**DEPARTMENT OF TRANSPORTATION
STATE OF GEORGIA
REVISED PROJECT CONCEPT REPORT**

Project Type: <u>Major</u>	P.I. Number: <u>122890</u>
GDOT District: <u>1</u>	County: <u>Clarke</u>
Federal Route Number: <u>US 78</u>	State Route Number: <u>SR 10</u>

This concept revision includes changes in lane layouts, lane widths, shoulder widths, driveway access, removal of bike lanes and updated traffic volumes throughout the project corridor.

NH000-0003-03-(053) - CLARKE, P. I. NO. 122890
SR 10 LOOP AT ATLANTA HWY INTERCHANGE
SR10 LOOP, JENNINGS MILL RD & HUNTINGTON RD
CURRENT LAYOUT AS OF 8-31-2015

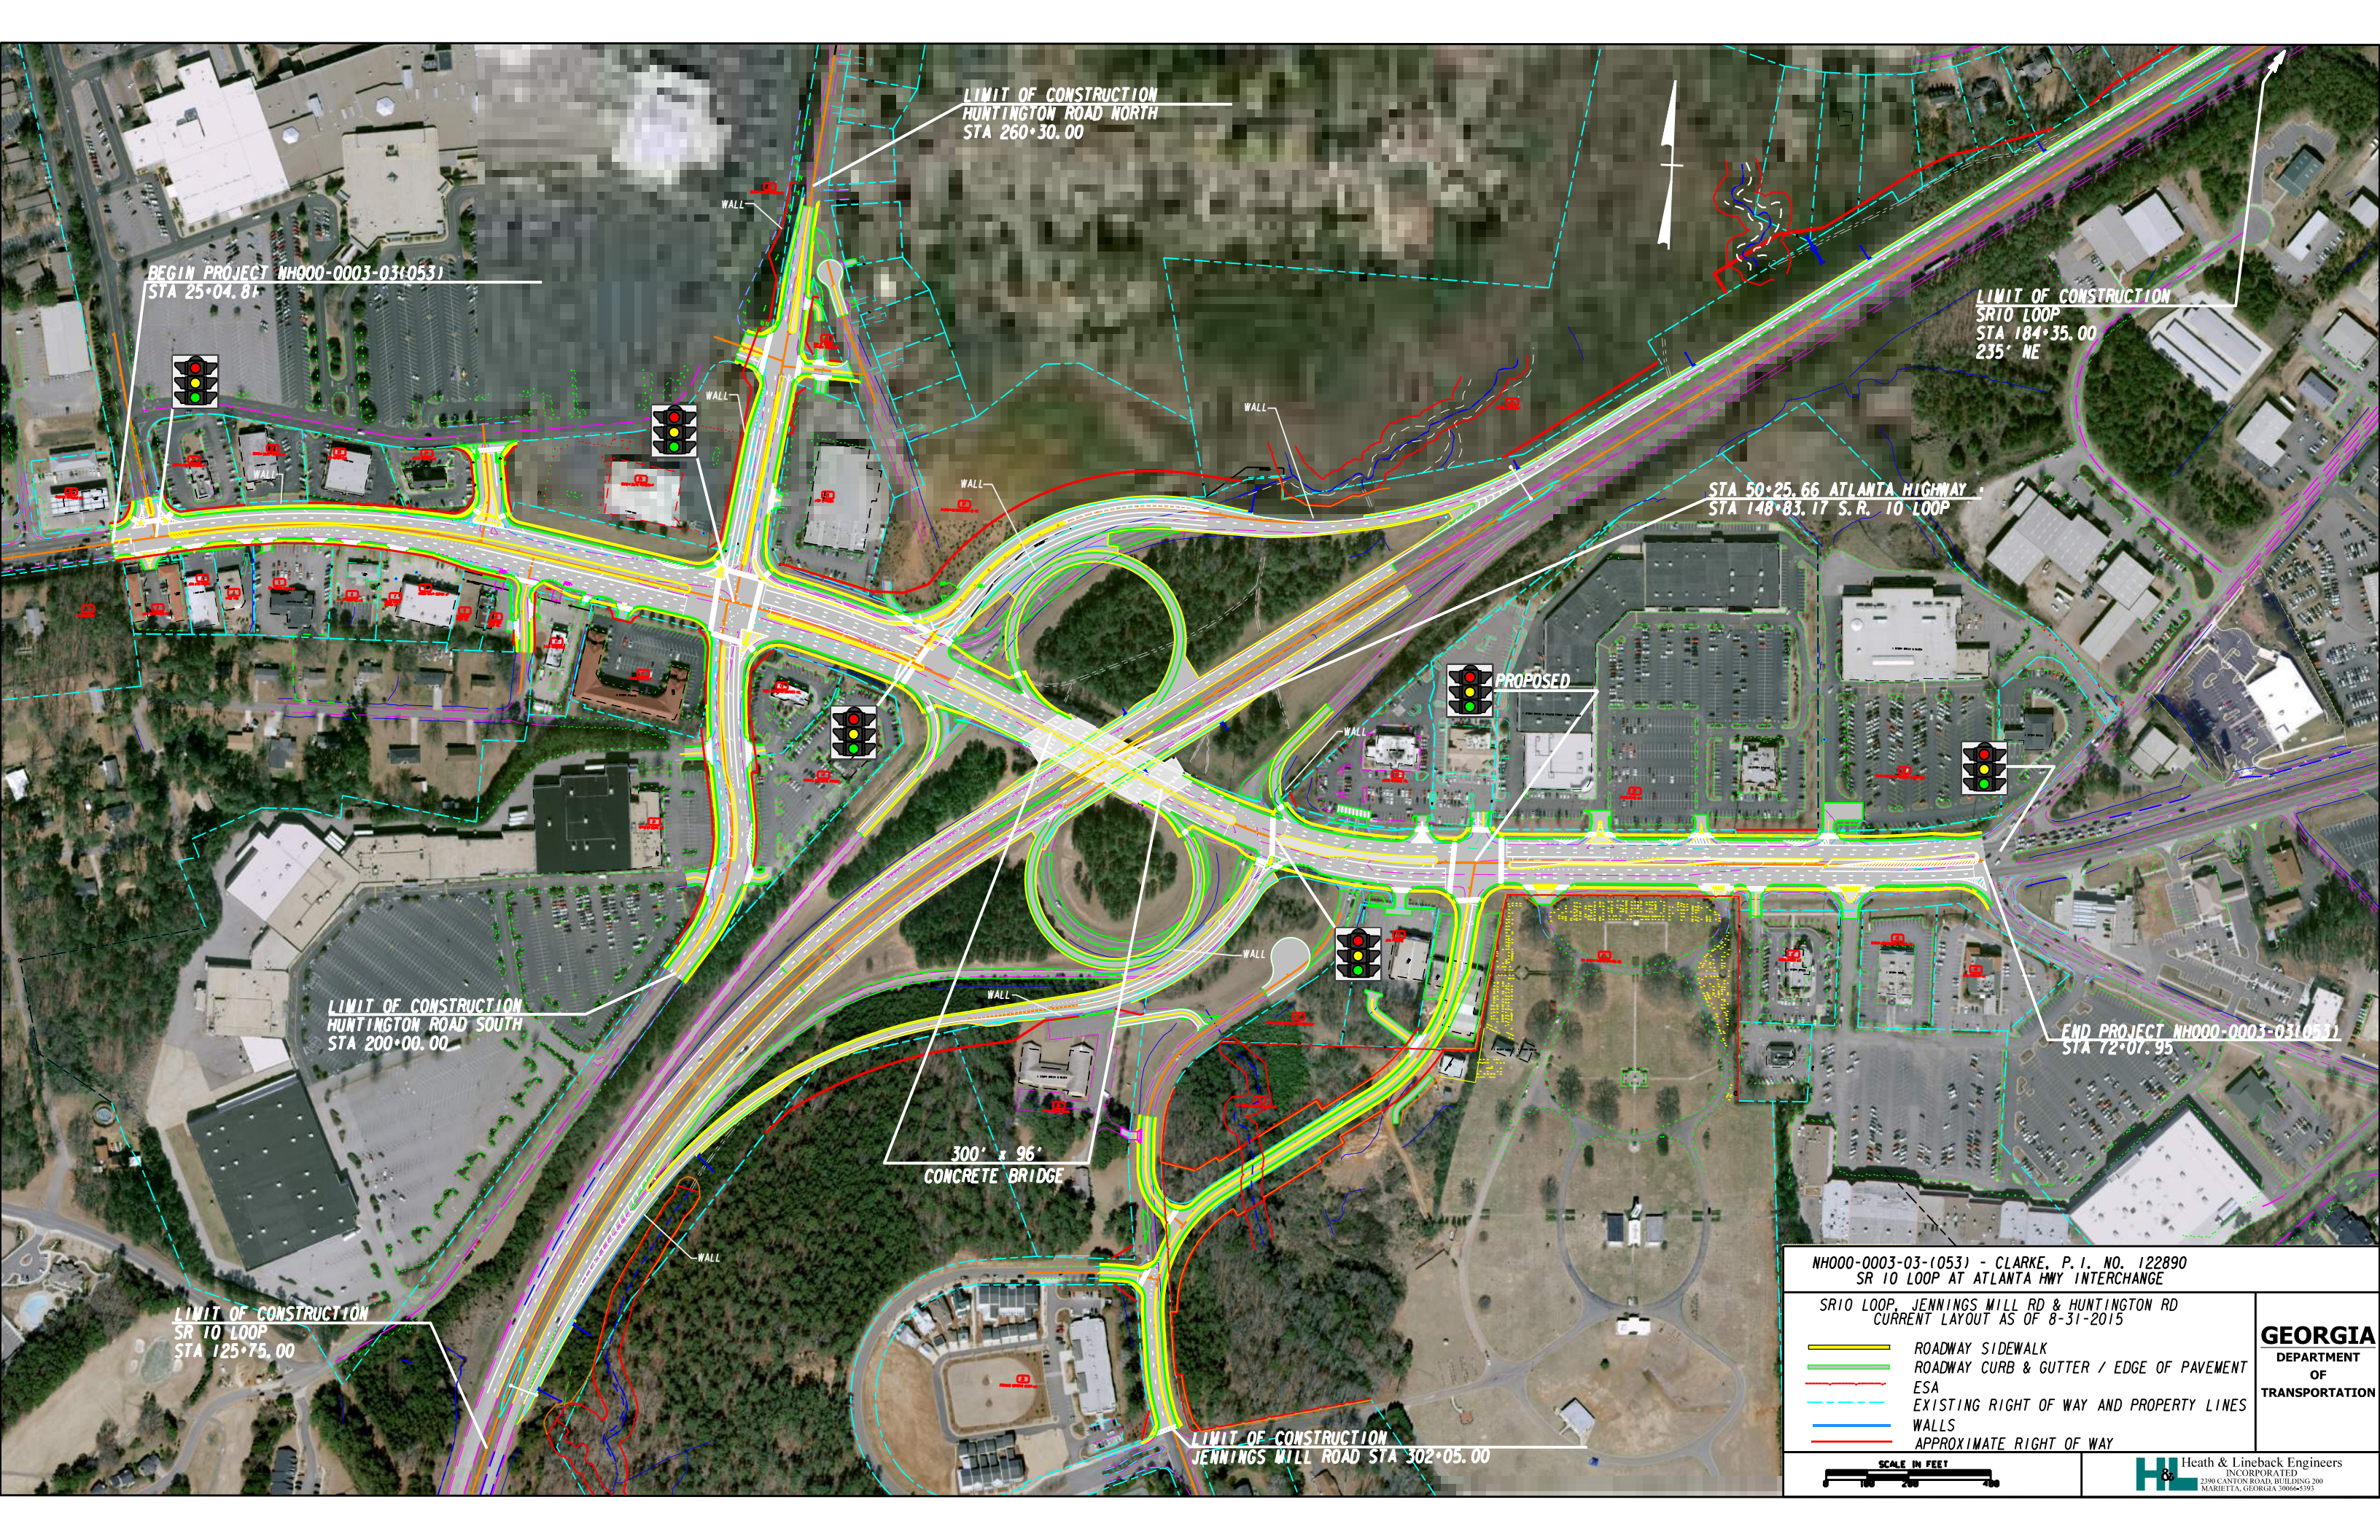
Approved Features:	Proposed Features:
Typical Section (Atlanta Hwy): <ul style="list-style-type: none"> • 12'-0" Lane Widths • 4'-0" Bike Lanes • 16'-0" Shoulders 	Typical Section (Atlanta Hwy): <ul style="list-style-type: none"> • 11'-0" Lane Widths • No Bike lanes • 8'-0" to 16'-0" Shoulders
Typical Section (Huntington Road): <ul style="list-style-type: none"> • 16'-0" Shoulder 	Typical Section (Huntington Road): <ul style="list-style-type: none"> • 10'-0" Shoulder
Typical Section (Jennings Mill Road): <ul style="list-style-type: none"> • 16'-0" Shoulder 	Typical Section (Jennings Mill Road): <ul style="list-style-type: none"> • 10'-0" Shoulder
Project Concept Layout: <ul style="list-style-type: none"> • 4 lanes in each direction through the interchange area 	Project Concept Layout: <ul style="list-style-type: none"> • 3 lanes in each direction through the interchange area
Reason(s) for change: ROW is the highest cost item on this project. Reducing the widths and shoulder widths will result in significant cost savings (pavement bridge and ROW) and also reduce / minimize the amount of new ROW required to construct the project. The bike lane would not tie to any proposed bike routes designated by GDOT or Athens-Clarke County.
